**Planning
Authority
Agenda**

2 July 2024

6.1 Development Application DA 2024/0061 - Multiple Dwellings x 53 (51 new, 2 existing) at 24B & 38 Jetty Road, Old Beach

Figure 4: Building Envelope Diagram 1 showing envelope protrusion for units 23 and 24, and eaves excluded by 8.4.3 A3 from southern boundary (source: Application documents)

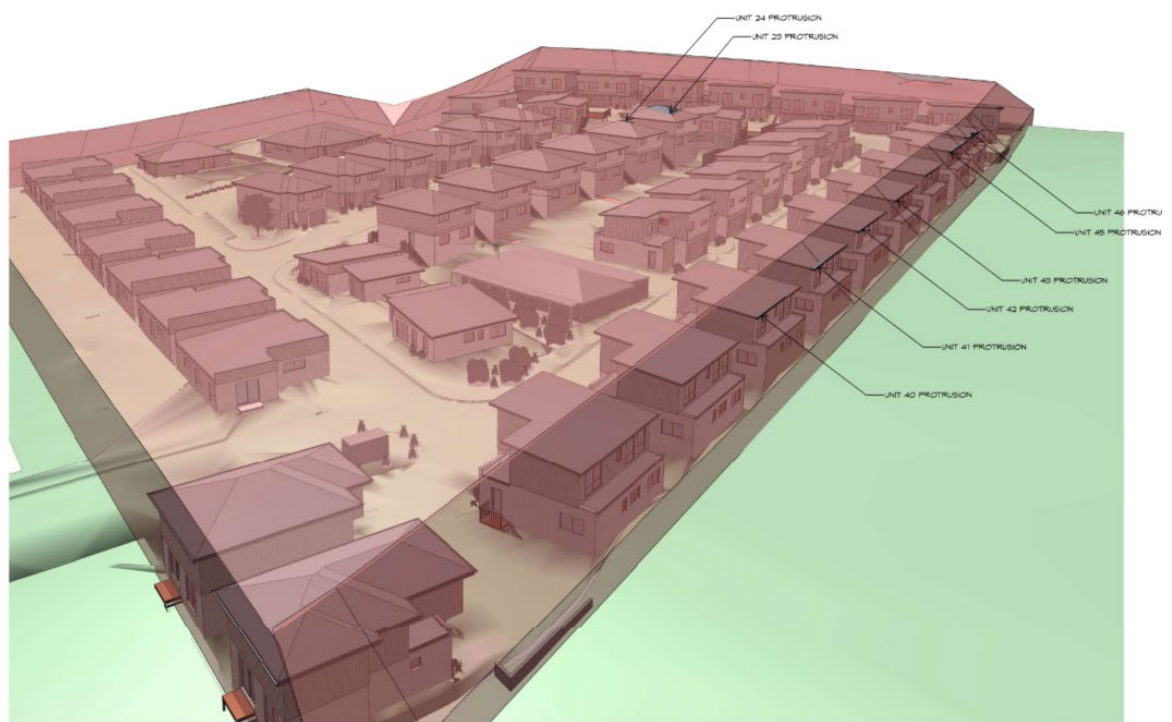
The proposal exceeds the building envelope for dwellings 21, 23 and 24, located in the centre of the site, whilst the protrusions for eaves along the southern boundary (being units 40 – 46) and northern boundary (unit 21) are excluded under 8.4.2 A3. The acceptable solution is not met, and assessment against the performance criteria is relied upon.

Figures 4 and 5 shows the Building Envelope Diagrams which form part of the proposal plans (sheet PD23405-09 Revision 05). The diagrams show the areas located outside of the building envelope.

The applicant has confirmed that it will reduce the height of units 21, 23 and 24, to ensure that all dwellings comply with the Acceptable Solution for building envelope required by 8.4.2. A3, and has requested that a condition be included in any permit requiring amended plans to be submitted to Council for approval, prior to commencement of any works or issue of any approvals required pursuant to the *Building Act 2016*.

- (a) the height of dwellings 21, 23 and 24 lowered to comply with the building envelope prescribed by 8.4.2 A3 of the Tasmanian Planning Scheme – Brighton.
